# Correspondence with NSW EPA on Noise and Air Quality

**Bylong Coal Project EIS  
Meeting with EPA to Discuss PAC Review Report**

**Bylong Coal Project EIS  
Response to NSW EPA Submission, Dated 17 August 2016**

**Subject: Bylong Coal Project - Response to PAC report**

Figure 1 - Combined open cut mining area stored inventory

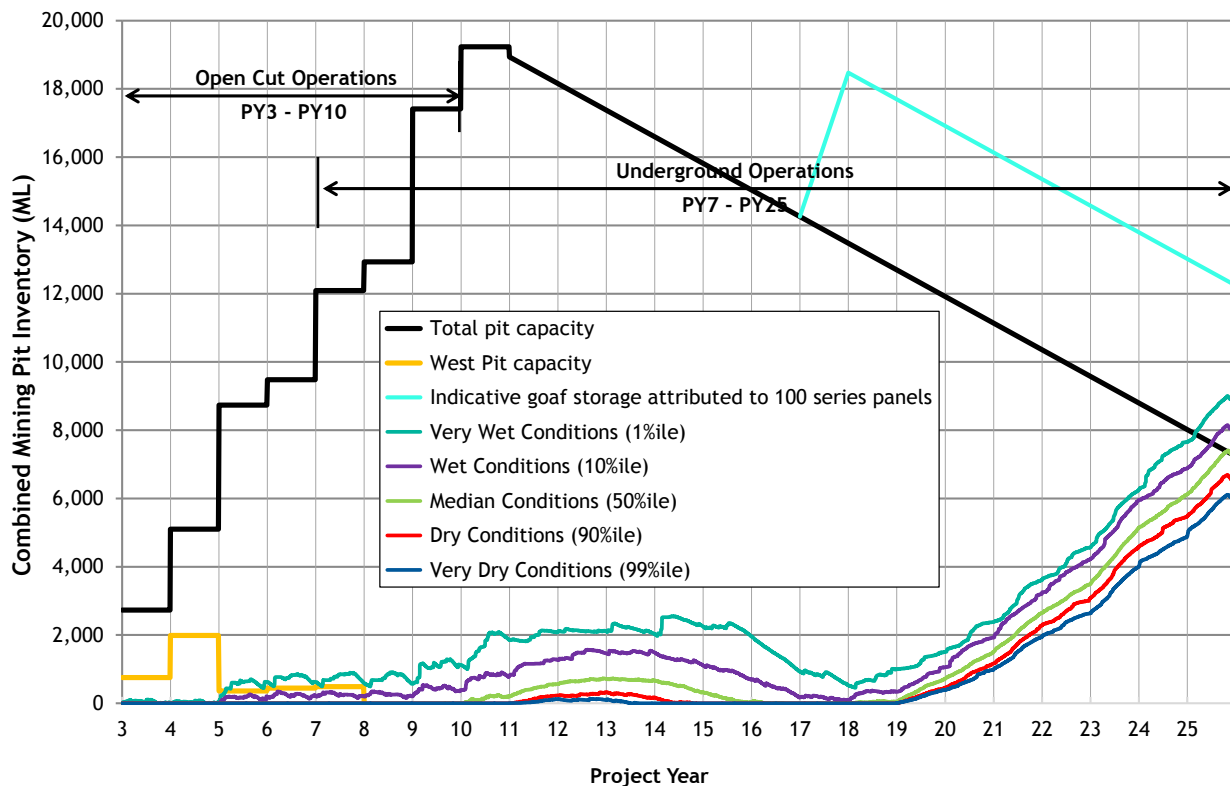
- the risk that mine water on the site will exceed the available storage capacities, resulting in the need for controlled or uncontrolled water releases from the mine water system; and
- potential impacts of mine water releases (notwithstanding that releases of mine water are not proposed) on the flow volumes and salinity in the Goulburn River.

Figure 1 shows an updated plot of the likely range of potential water storage volumes required in the open cut mining area to prevent spills from the mine water system, depending on climatic conditions. The results shown in Figure 1 are based on the revised groundwater inflows shown in Table 1, with inflows varied from year to year, rather than averaged across mine stages as assumed in the assessments from the EIS and the Supplementary RTS.

Figure 1 also shows the total water storage capacity of the open cut pits (mostly provided by East Pit), as well as indicative storage in the underground goaf (attributed to the 100 series longwall panels) which will be available from the latest PY 18. The reduction in water storage capacity over time from Year 11 is due to the placement of coal reject material within the open cut void such that at the end of underground mining it can be capped and rehabilitated. This will enable the entire open cut mining area being rehabilitated to a free draining landform and unlike most open cut mines will not comprise a final void.

Figure 1 shows that over most of the Project life, the available storage capacity within the open cut pits is significantly higher than the 1<sup>st</sup> percentile prediction (very wet conditions) of the required water storage volume. Even if very wet climatic conditions occur, the available storage volume at the very end of Project life exceeds the required storage volume by more than 3,400 ML. Once the 200 series longwall panels are extracted, the entire underground mine will become available for storage which will further increase the available storage volume.

Figure 2 - Sensitivity Case 1 results for stored water inventory (Revised runoff)

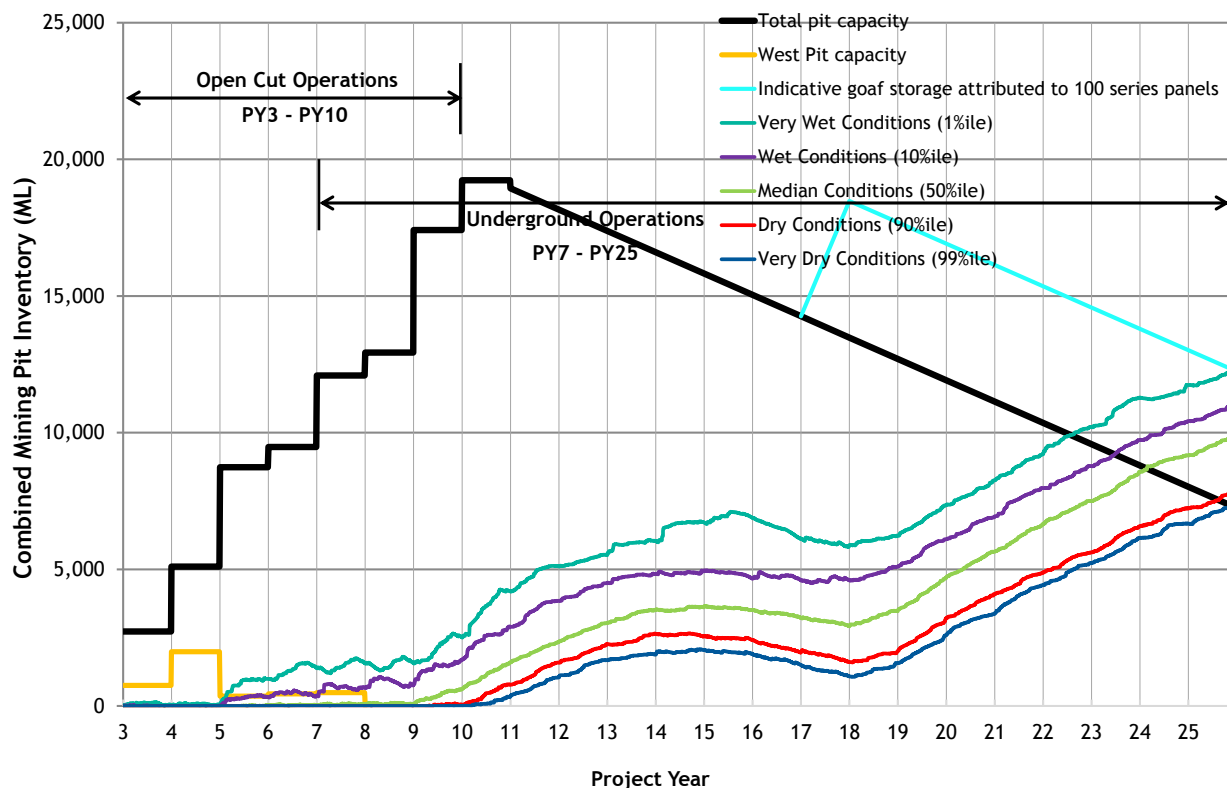
In response to a peer review of the water balance modelling completed within the EIS by Hydro Engineering & Consulting (HEC), an additional five water balance modelling cases have been assessed with different assumptions for surface runoff and groundwater inflows. The adopted cases are summarised in Table 2. The approach for selecting the sensitivity cases is described as follows:

The sensitivity results for the stored water inventories are shown in Figure 2 for the Revised Runoff sensitivity case (Case 1). The revised runoff parameters and groundwater inflows result in generally higher stored water volumes over the life of the Project when compared to the Supplementary RTS case. The available storage capacities (shown in Figure 2) would be sufficient to contain water volumes under this scenario over the Project life. As noted above, many years of mining operations will be available to validate the groundwater model and refine the groundwater inflows and the performance of the water management system and make any necessary changes to the sites water storage capacities to ensure the containment of mine water in the later years of the Project. In addition, inclusion of goaf storage for the 200 series longwall panels will provide additional storage capacity.

**Figure 4 - Goulburn River at Coggan - EC**

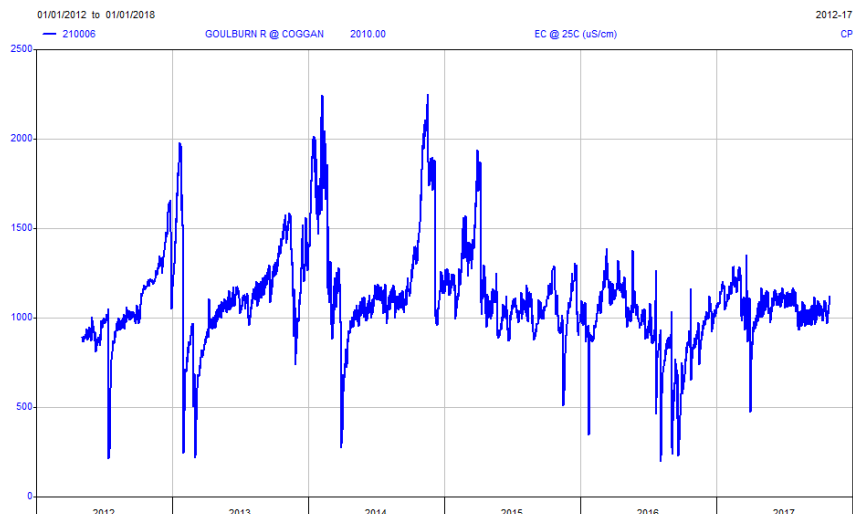
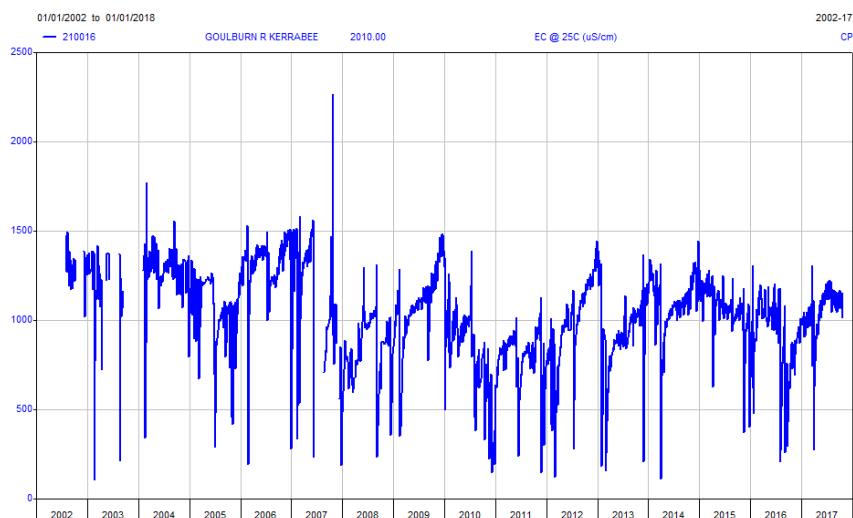
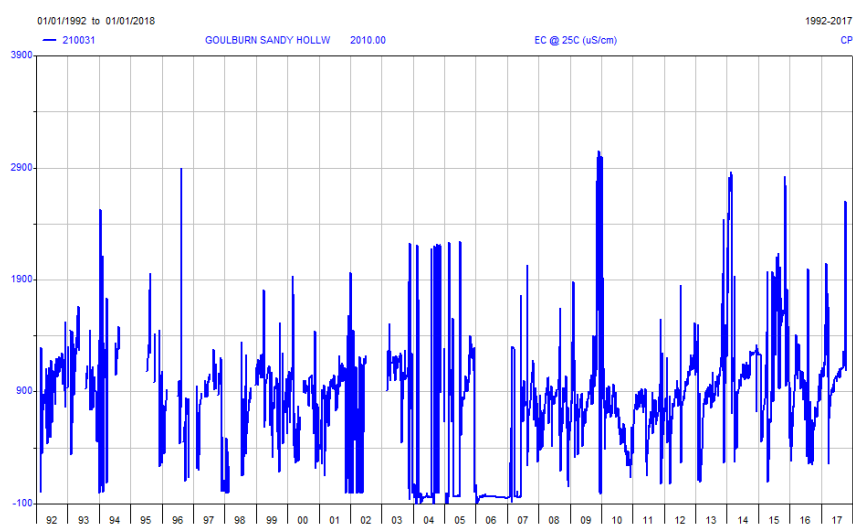
A presentation to the PAC at its public hearing from the Mudgee District Environment Group claimed that the Goulburn River was subject to increasing salinity from land clearing for agriculture, and more recently from open cut mining.

Details of the three closest stream gauging stations on the Goulburn River downstream of the Bylong River confluence are provided in Table 4. Figures 4, 5 and 6 show time series plots of salinity (Electrical Conductivity (EC)) for the available period of record at each of these three gauges. Inspection of the historical time series EC data does not indicate an obvious increasing trend. Hence, the available historical data does not provide strong evidence that the Goulburn River salinity, downstream of the Bylong River, is increasing in response to mining or other land use impacts.

Water within the proposed Bylong mine water management system that may have elevated salinity levels will be recycled within the site water management system and managed to prevent any discharge. Hence, operation of the Project will have no measureable impact on the salinity in the Bylong River or the Goulburn River.
